## Product/Process Change Notice - PCN 21\_0101 Rev. -

**PCN Title:** ADIS1648X IMU Package Dimension Tolerance Change

## ADiS IMU 44X47X14 Package Outline Drawing (First used on ADiS16375)

REV G

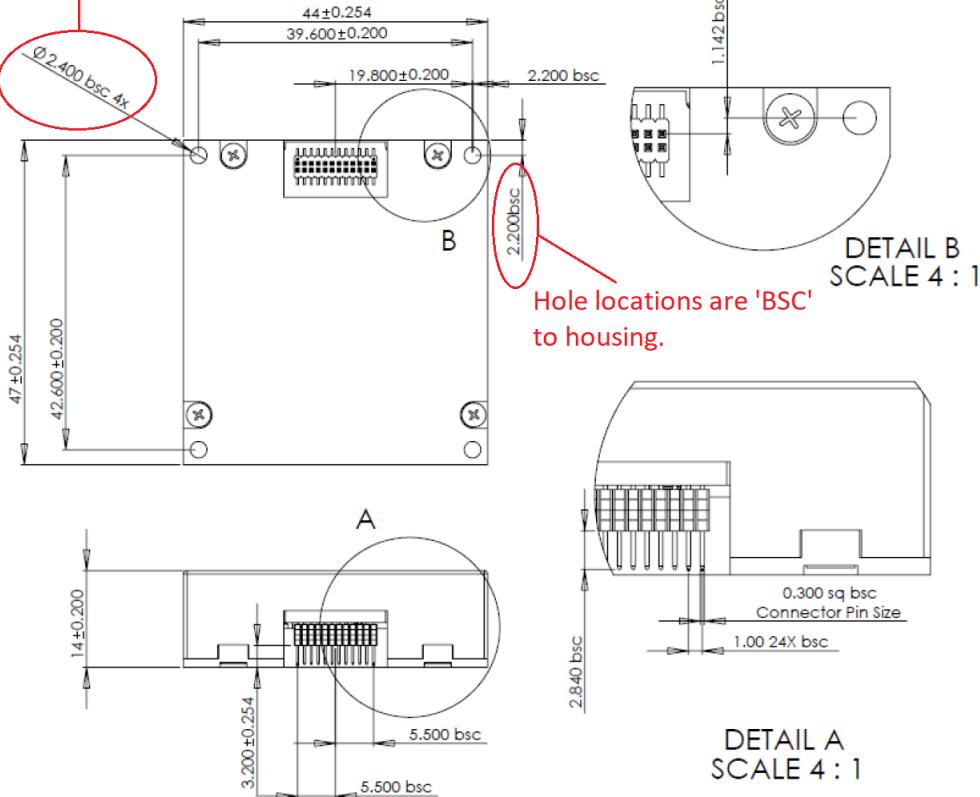
Hole diameters are not  
toleranced (BSC)

REV H

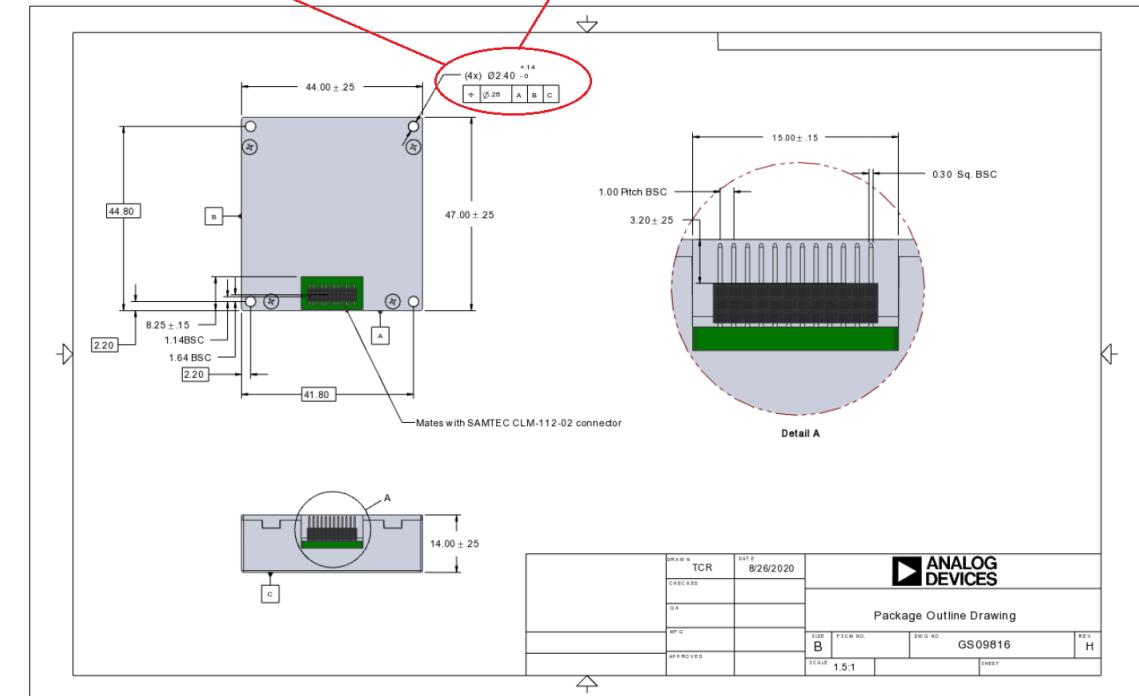
**Mounting hole diameters are  
toleranced.  
(from a non-tolerance)**

Utilizes GD&T to accurately locate mounting holes. Holes are in same location.

These changes allow customers to accurately and repeatably place the mating fastener holes. This has been at our primary customer's request.
